Description of Changes

Item	Control (SM9GV -> OTR_PF1_23)
Before	
After

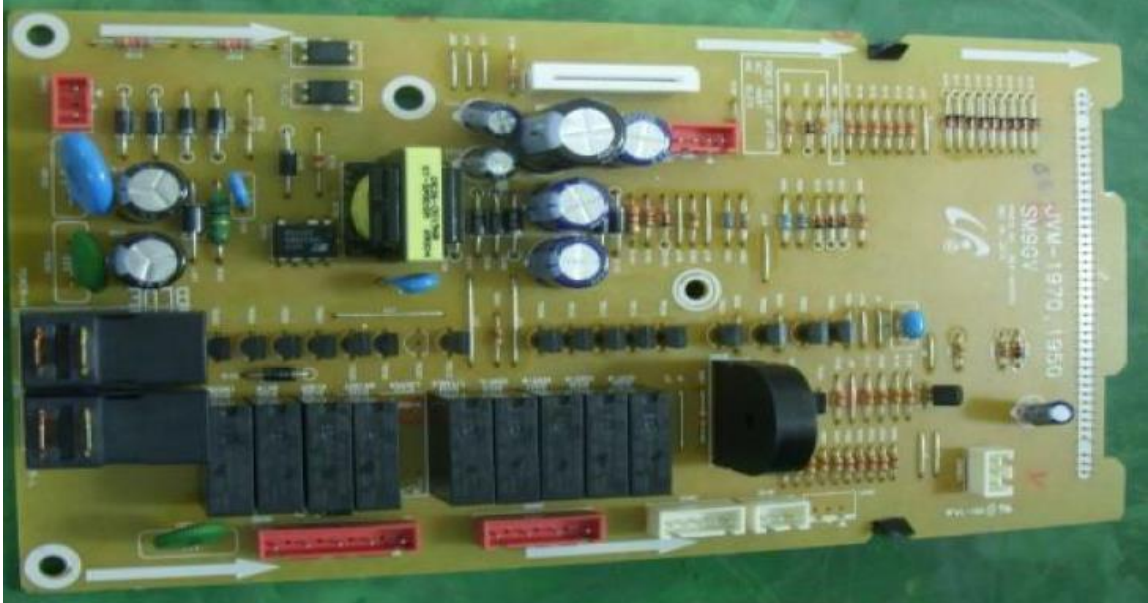
1. There is change of control board
 - 1) Add wireless module by FCC certified
 - 2) New control board (Non-transmitter portion)
 - Overcurrent protection design (Fuse+add NCT)
 - Temperature protection design (add OTP circuit)
